South Texas Project
Units 3 and 4
Docket Nos. 52-012 and 52-013
Response to Requests for Additional Information

08.03.01-4, Supplement 2

RAI 08.03.01-4, Supplement 2:**Response Supplement 2**

FIGURE 8.3-1 ELECTRICAL POWER DISTRIBUTION SYSTEM SINGLE LINE DIAGRAM (SHEET 1 OF 4)
 STP 3 & 4 REV. 2

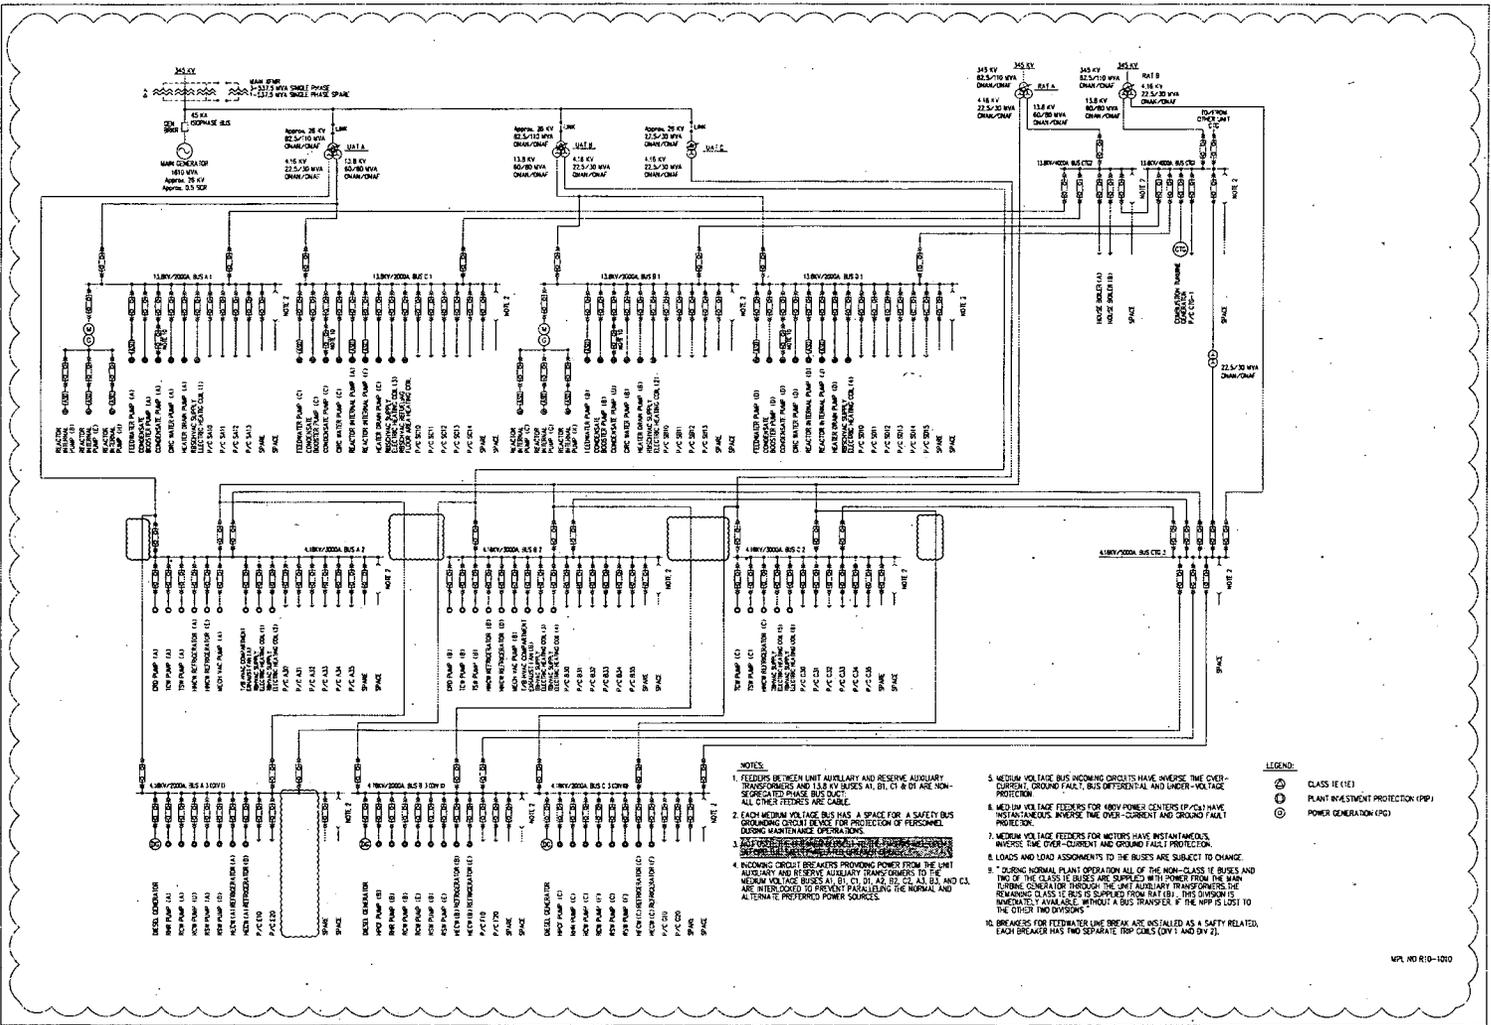
The capability to power the FMCRDs directly from a PIP bus and the direct transfer capability is changed to occur at the 480 volt level. These changes are reflected in FSAR Sections 8.3.1.1.1, Figures 8.3-1, Sheet 1, 3 and 4 and FSAR Table 9A.6-2 Fire Hazard Analysis.

FIGURE 8.3-1 ELECTRICAL POWER DISTRIBUTION SYSTEM SINGLE LINE DIAGRAM (SHEET 3 OF 4)

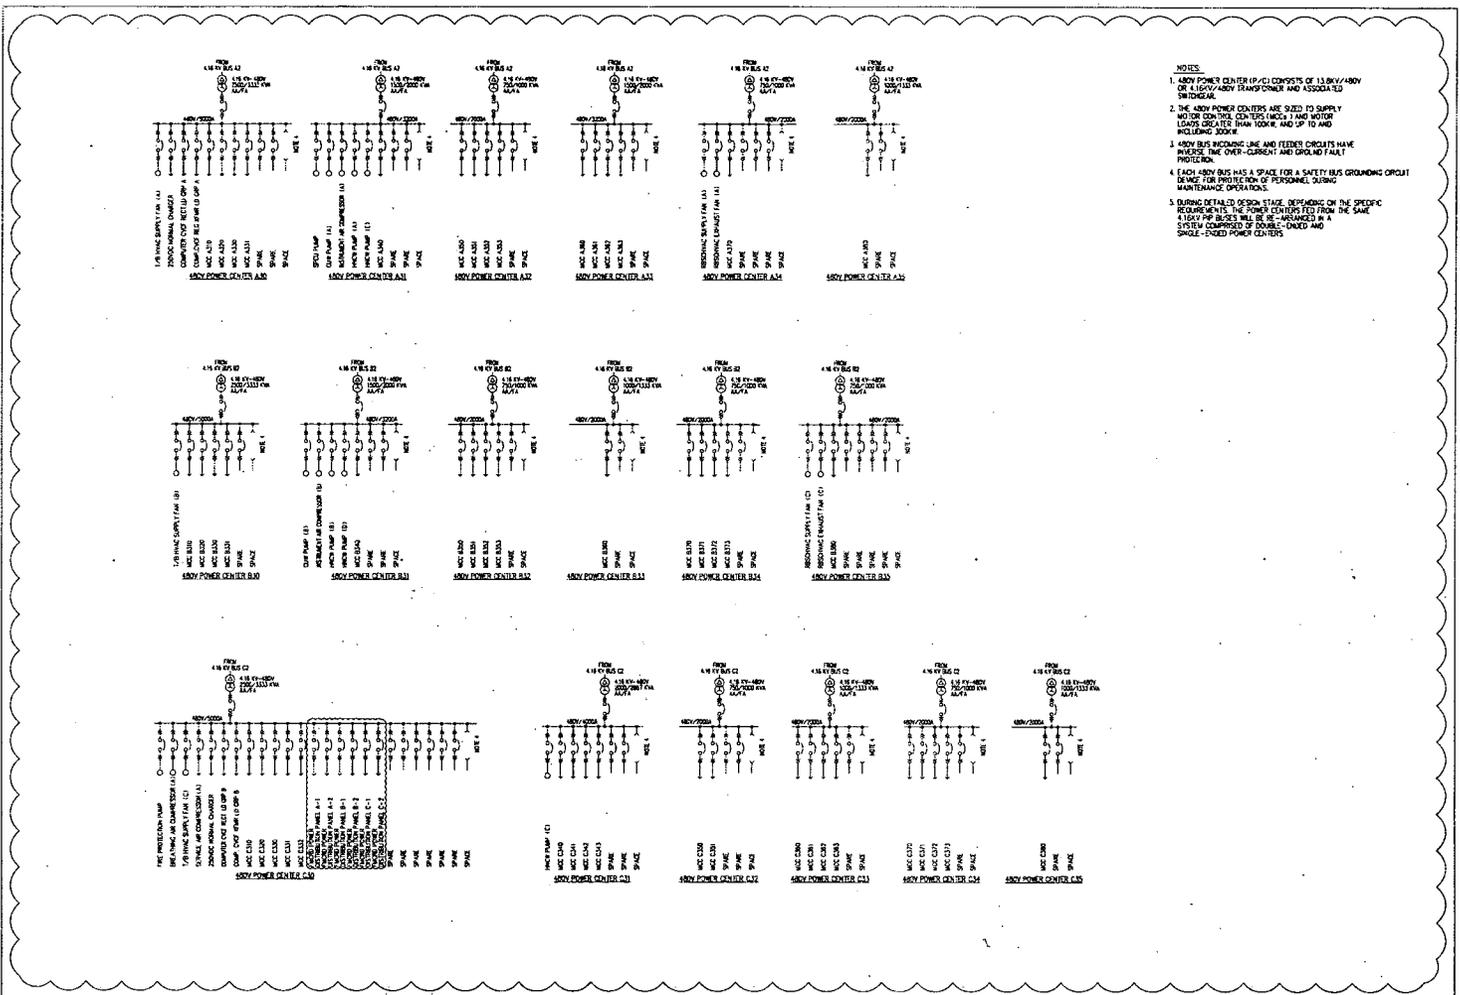
The design minimizes the probability of a single failure affecting more than one FMCRD group by providing ~~six three~~ independent Class 1E feeds (~~two one~~ for each group) directly from the Division 1 Class 1E ~~6.9, 4.16 and PIP 480 kV buses~~ (see sheet 3 sheet 3 and 4 of Figure 8.3-1).

FIGURE B.3-1 ELECTRICAL POWER DISTRIBUTION SYSTEM SINGLE LINE DIAGRAM (SHEET 4 OF 4)
Rev 2
STP 3 & 4

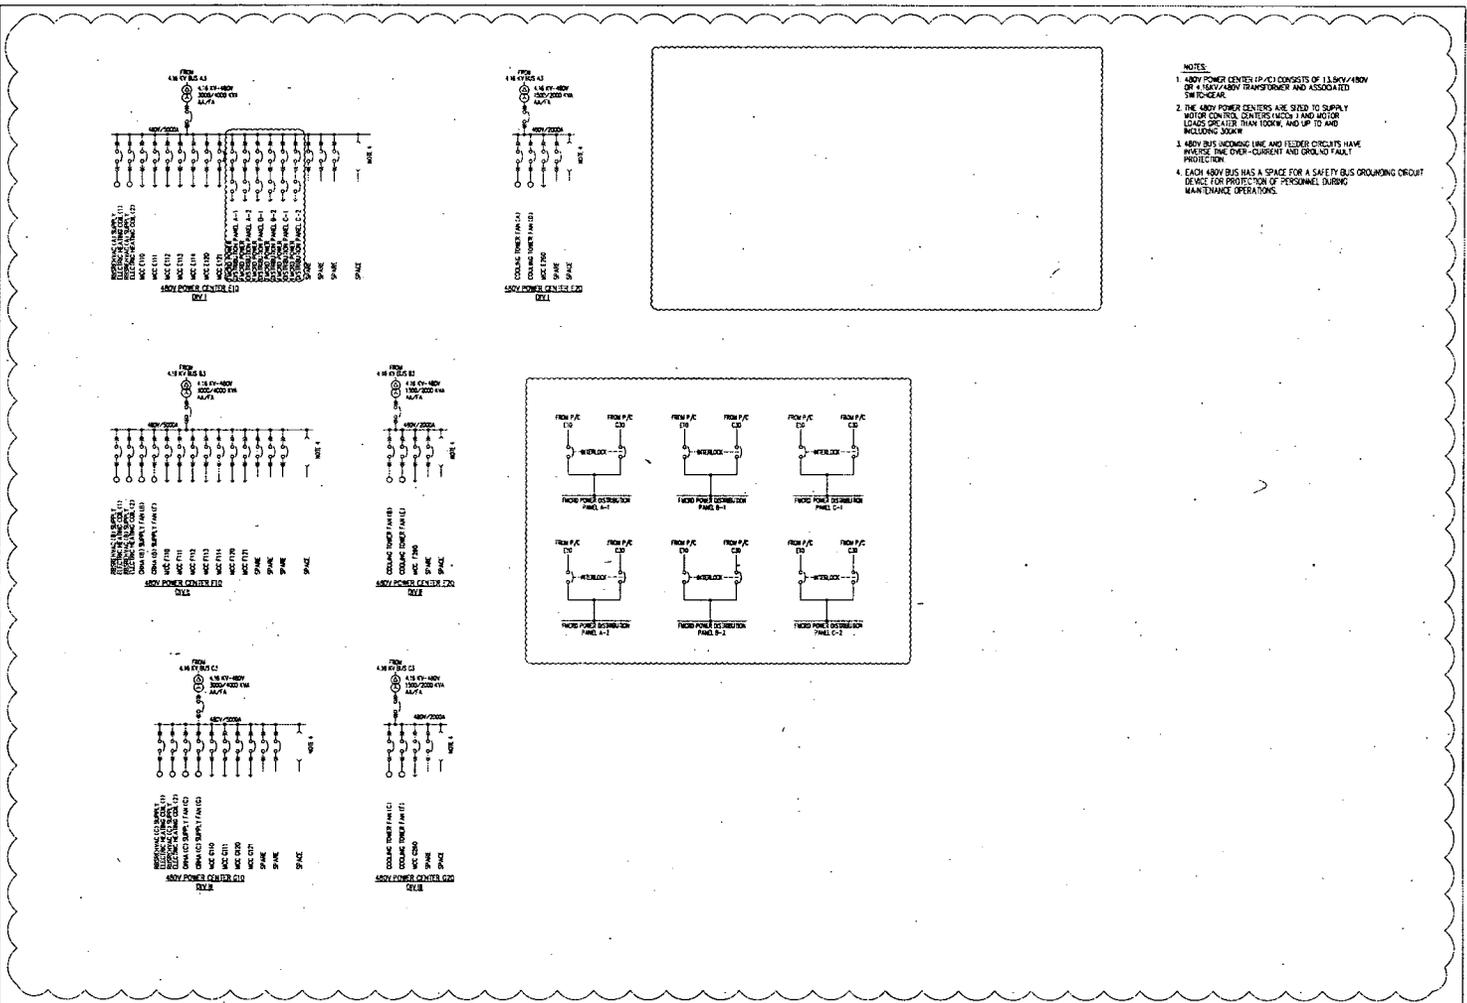
Additionally, the following changes revise and clarify FSAR Chapters 7, 8 and 19 to indicate that the 480V power supplies to the FMCRD power distribution panels A-1, A-2, B-1, B-2, C-1 and C-2 will be non-Class 1E. Electrical interfaces between Class 1E and non-Class 1E circuits utilize Class 1E isolation devices (FSAR, Tier 2 - 8.3.3.6.2.2.4). Electrical isolation of power circuits is achieved by Class 1E isolation devices (such as circuit breakers or fuses) applied to interconnections of Class 1E and non-Class 1E circuits as defined by Regulatory Guide 1.75 and IEEE 384. The method of achieving electrical isolation of power circuits is to utilize isolation devices as shown in FSAR Figure 8.3-1, Sheet 4.
